Resolution No. 2024-75

Approving Change Order No. 1 for 61st
Avenue Parklet Project

Change Order Summary

Finish Grade Aggregate Base

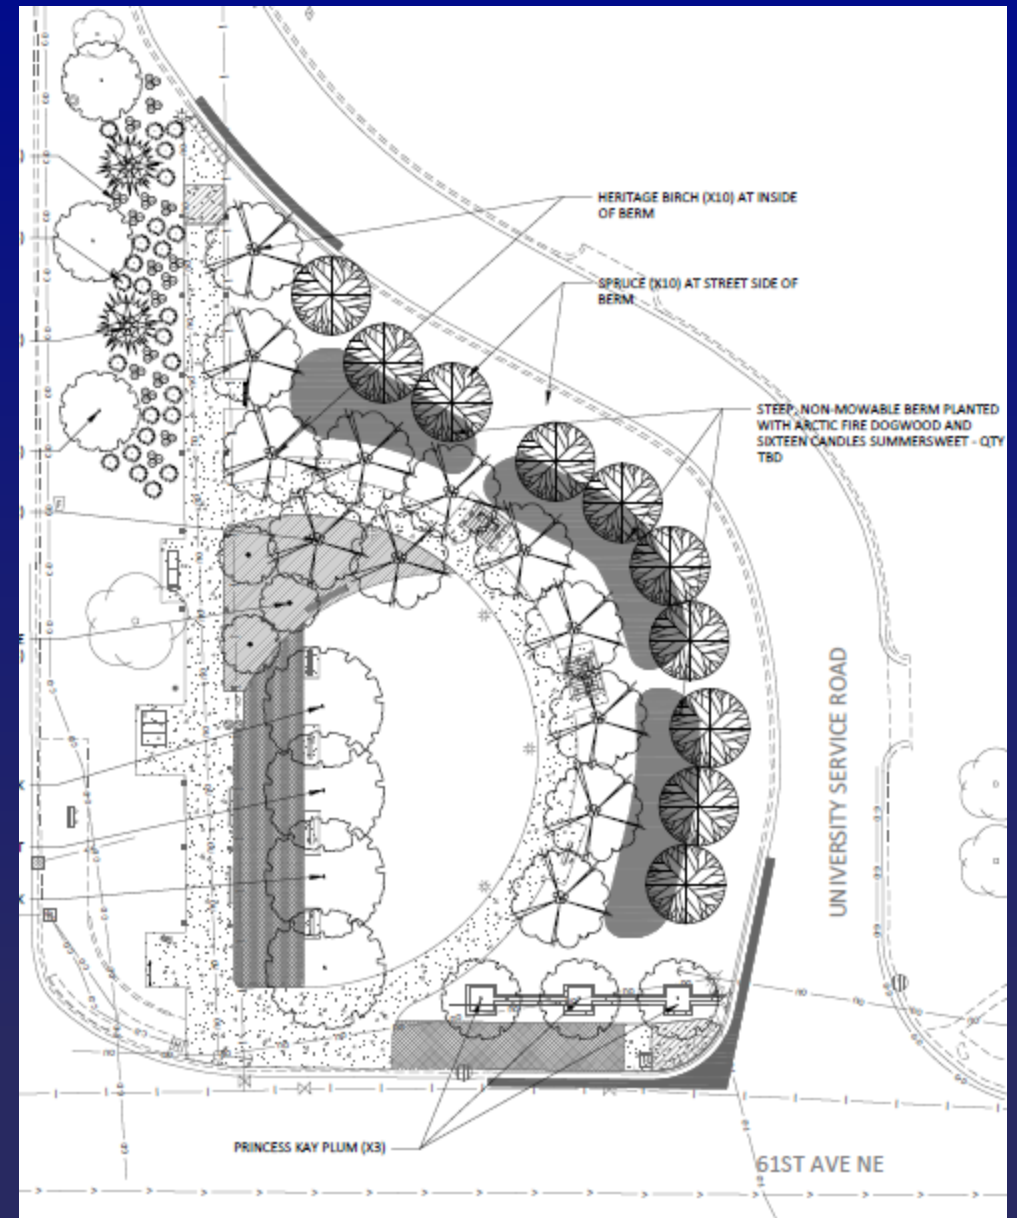
- Additional aggregate base material was required for the installation of the utilities needed for the water wall
- Grading was modified in the paver area to better tie into the existing curb line and improve accessibility
- Accounted for \$1,920.00 of the change order
